FECAL COLIFORM TOTAL MAXIMUM DAILY LOAD FOR WHITEWOOD CREEK

Topical Report RSI-2118

South Dakota Department of Environment and Natural Resources 523 East Capitol Joe Foss Building Pierre, South Dakota 57501

7.0	PUI	BLIC PARTICIPATION	33
8.0	MO	NITORING STRATEGY	34
9.0	RES	STORATION STRATEGY	35
10.0	REI	FERENCES	37
APP	END	DIX A. BACTERIA SAMPLE DATA	A-1
APP	END	DIX B. U.S. ENVIRONMENTAL PROTECTION AGENCY REGION VIII TOTAL MAXIMUM DAILY LOAD REVIEW	B-1

Figure 1-1. Whitewood Creek Study Area.

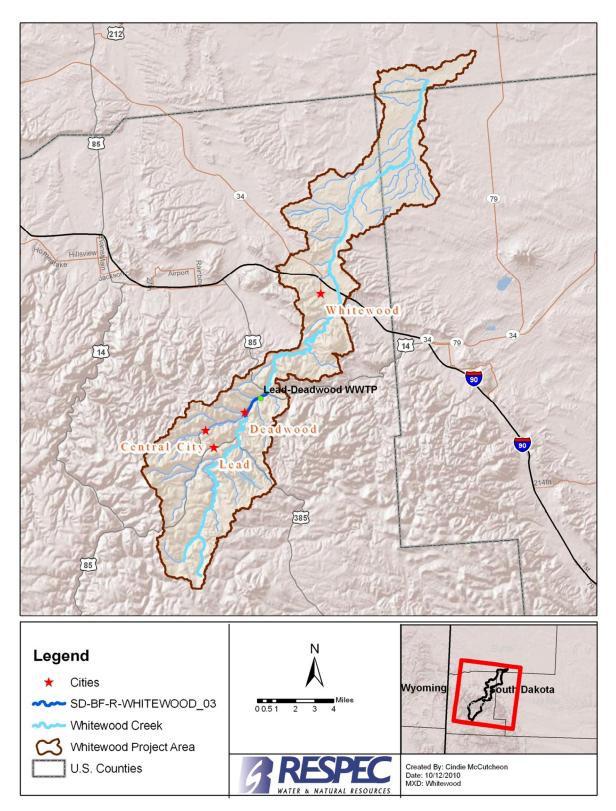
SD DENR Comments: The WWTP was added to the map of Whitewood Creek Watershed (Figure 1-1). The location was checked, and the WWTP is located within the impaired segment.

Figure 3-1. Ribotyping Locations.

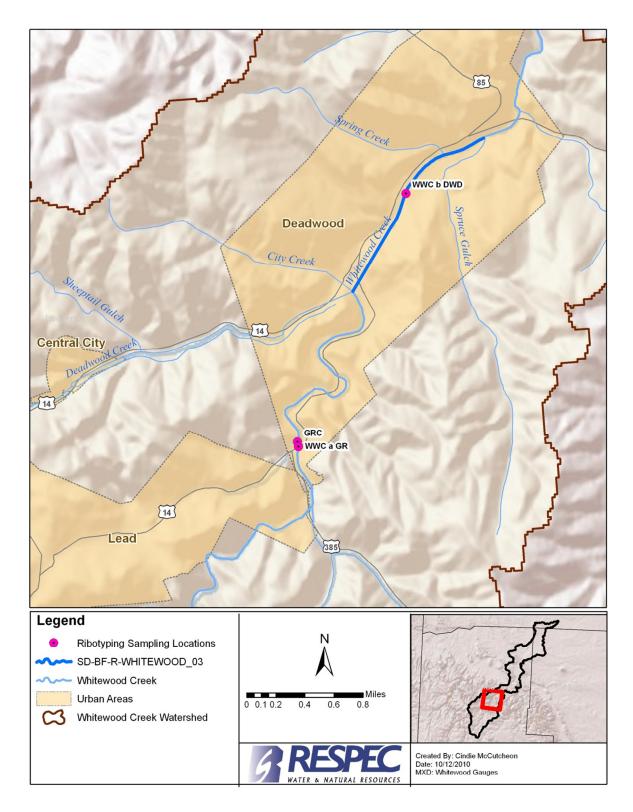
SD DENR Comments: An analysis of bacteria concentrations from upstream to downstream and information about potential localized sources and plans to investigate additional local sources was added to Section 1.3. Also, detail on on-site wastewater treatment systems, leaks in sewer lines, and the CSO was added to section 3.2.2. Further information on potential localized sources was also added to the ribotyping section discussing bacterial sources. A column showing ribotyping results during high flows was added to Table 3-3. An error was noticed in the mapped ribotyping location WWC b DWD and the map was updated accordingly.
